Campbell Reith Audit Query Number (As set out in Appendix 2 of revision D1)	Query	Applicant Response
1	An outline works programme is required, that should as a minimum provide details of main phases of work with anticipated commencement dates and durations.	Addressed in enclosed works programme.
2	Connection between head of underpinning and ground floor slab to be proved by calculation to demonstrate adequacy for transmitting shear force between underpinning and prop. Or underpinning wall to be designed as an unpropped cantilever.	Addressed in enclosed Construction Method Statement.
3	Design of continuity reinforcement required if propping not provided to each underpinning bay.	Addressed in enclosed Construction Method Statement.
4	Details of ground movement assessment are required, such as parameters used in the calculation as discussed in paragraph 4.8.	Addressed in enclosed Construction Method Statement.

76 Fitzjohns Avenue

Application ref: 2017/1047/P

Appendix 3 – Drawing to illustrate impermeable area.

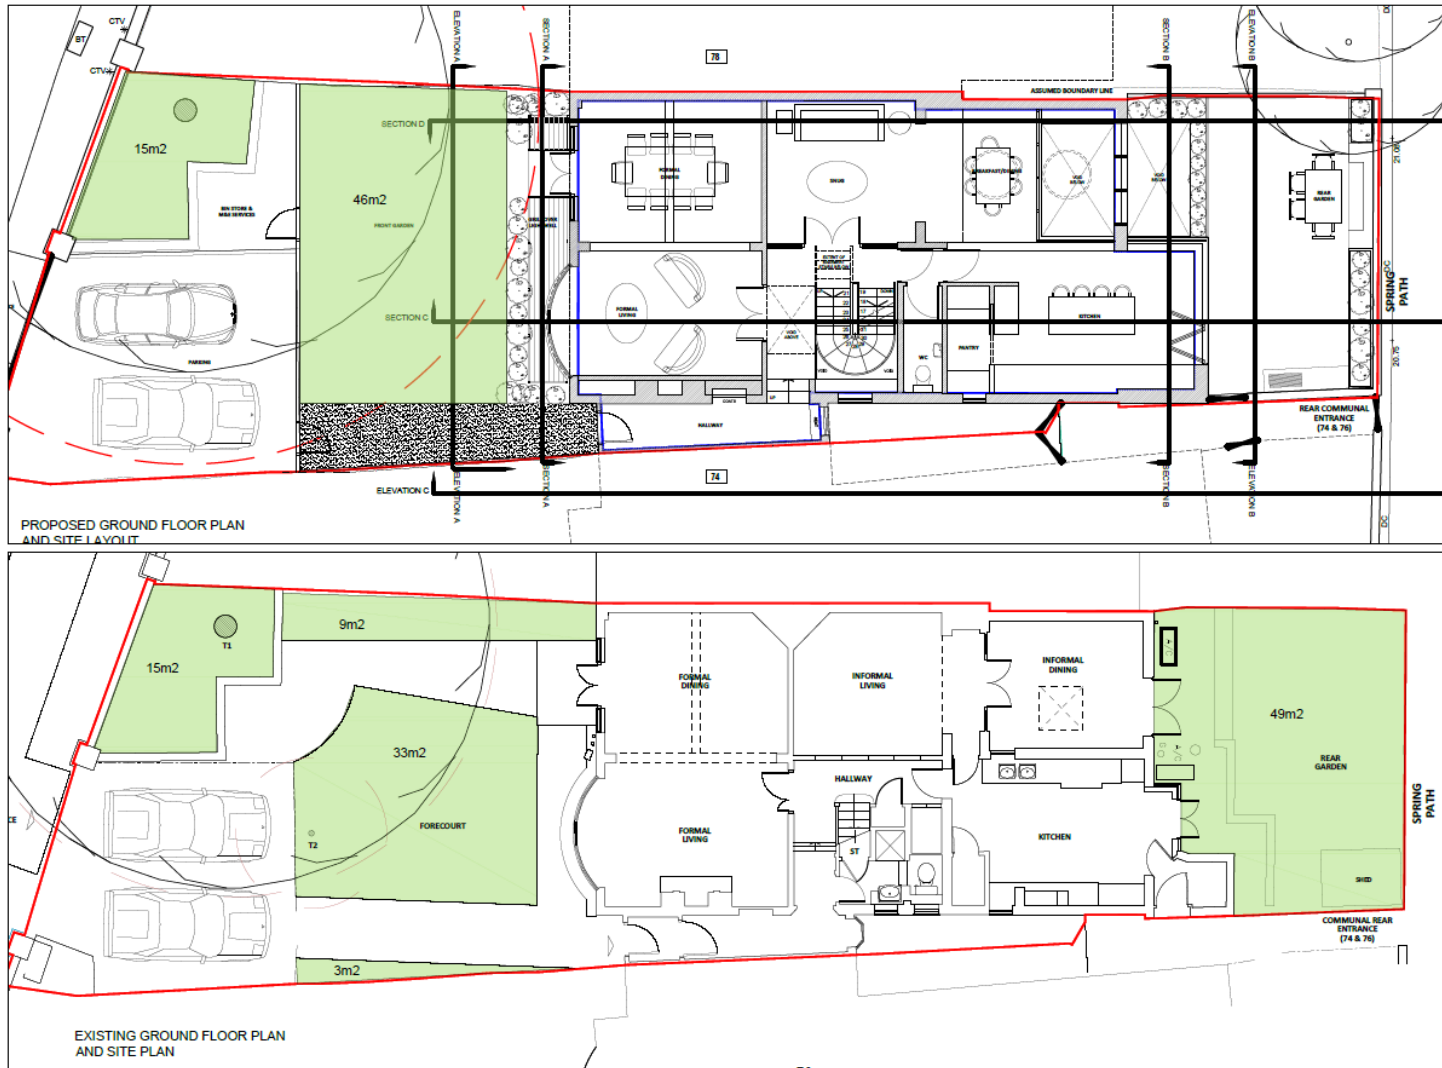
12	Evidence that the area of impermeable area is not increasing is required, given that the lightwells are impermeable. Details of SUDs are required should the impermeable area be increasing.	The amount of impermeable area is increasing by 1sqm. A drawing illustrating this is included in Appendix 3.
